MOD-WIFI-ESP8266-DEV, hardware revision B1

Major changes compared to hardware revision A:

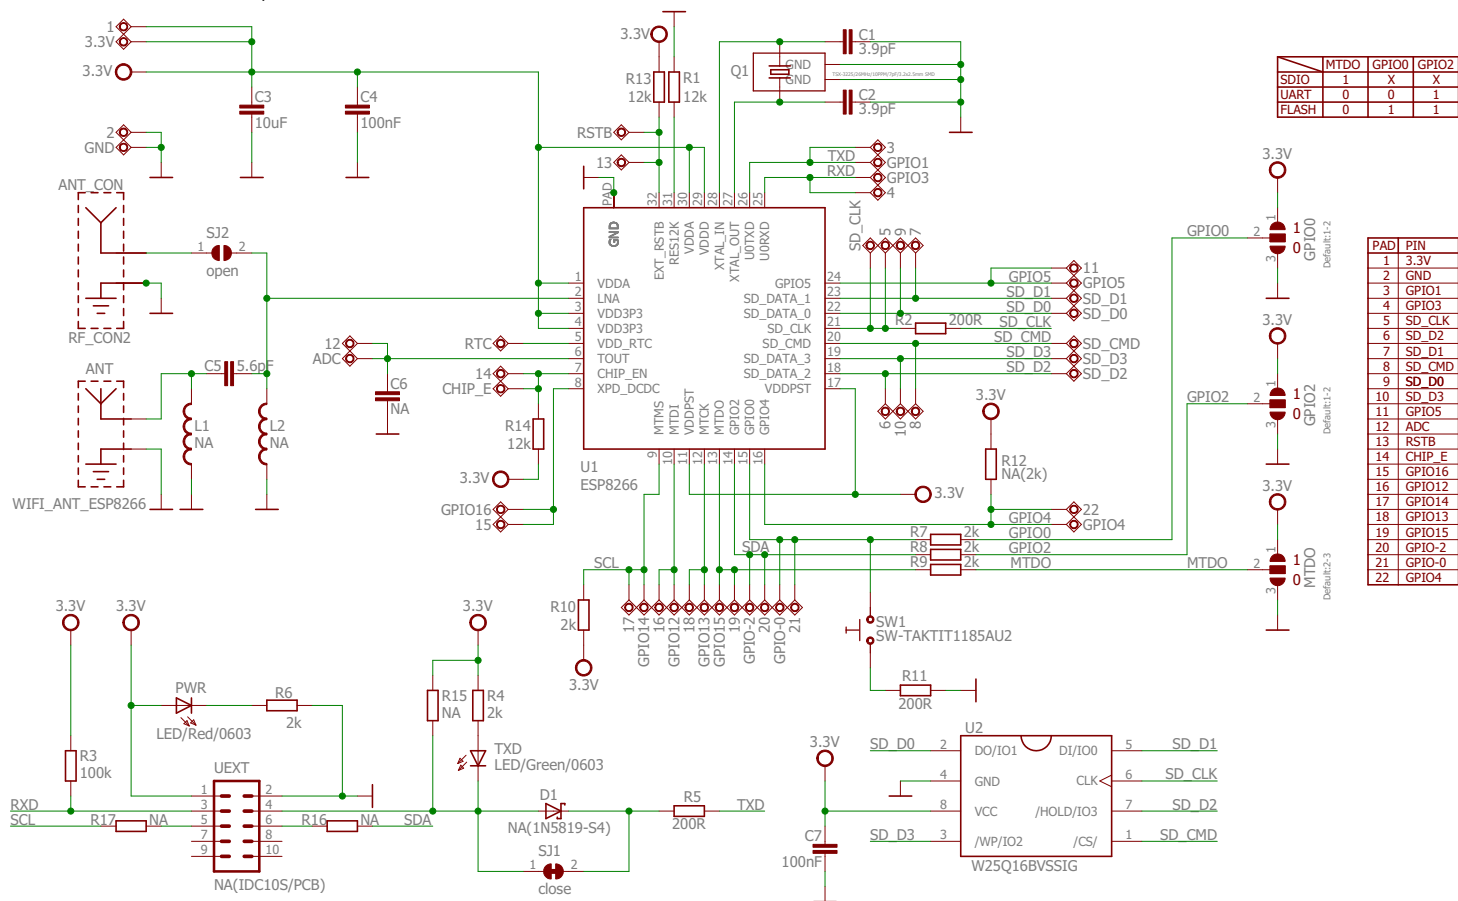
1. Added a button (and R11 to GND) to toggle GPIO0 easier. This is required to enter bootloader.
2. Added pads for optional pull-up resistor R12 at GPIO4 - if you are using I2C and you need pull-up.
3. Improved labels of jumpers.
4. Added test pad for the RTC pin.
5. Changed crystal and changed C1 and C2 from 10pF to 3.9pF. This improves WIFI connectivity.
